DESIGN <i>CB</i>	DRAWN BY <i>CB</i>	DART AEROSPACE LTD HAWKESBURY, ONTARIO, CANADA	
CHECKED <i>CE</i>	APPROVED <i>#</i>	DRAWING NO. DSI 9363	REV. A SHEET 1 OF 1
DATE 07.01.19		TITLE SHIM KIT	SCALE NTS
A	07.01.19	NEW ISSUE

DART SERVICE INSTRUCTION

TO AMEND INSTALLATION INSTRUCTIONS IIN-D412-694 REV. B AND INSTRUCTIONS FOR CONTINUED AIRWORTHINESS ICA-D412-694 REV. 1
 REF. CANADIAN STC: SH05-10
 REF. FAA STC: SR02086NY

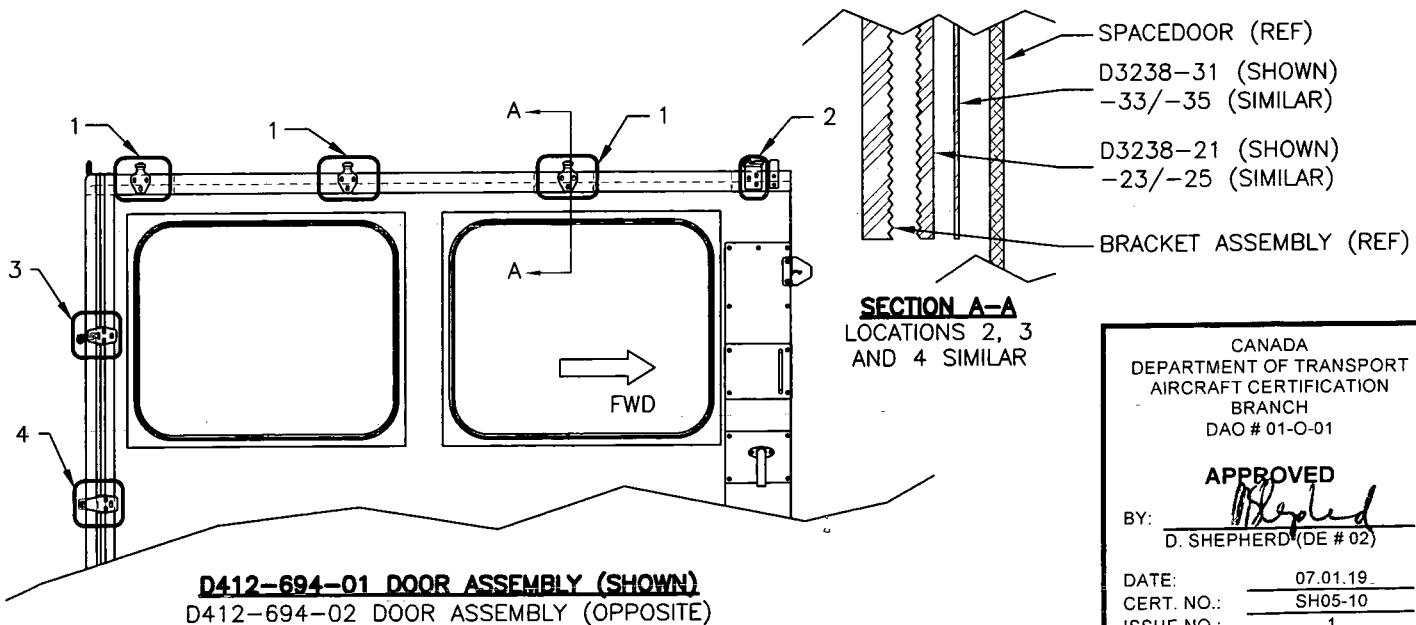
Dart has created the optional DSI-9363-011 Shim Kit that may be installed between the D3121-041/-043/-044, D3183-041/-042 and D3137-041 Bracket Assemblies and the Spacedoor™ to improve grip between the Bracket Assemblies and the Spacedoor™. This kit may be installed as a replacement for or in addition to the AN960JD10 Washers and/or the D3090-1/-3 Shims used to shim the Bracket Assemblies as described in the Installation Instructions.

The serrated faces of the D3238-21/-23/-25 Plates should be installed against the serrated faces of the Bracket Assemblies to ensure positive locking as shown in **Section A-A**. The D3238-31/-33/-35 Plates, the AN960JD10 Washers and the D3090-1/-3 Shims can be installed as required between the D3238-21/-23/-25 Plates and the Spacedoor™ to achieve good door alignment.

The Table and Figure below show the location, the quantity and the part number of each Plate and the corresponding Bracket Assemblies on the Spacedoor™.
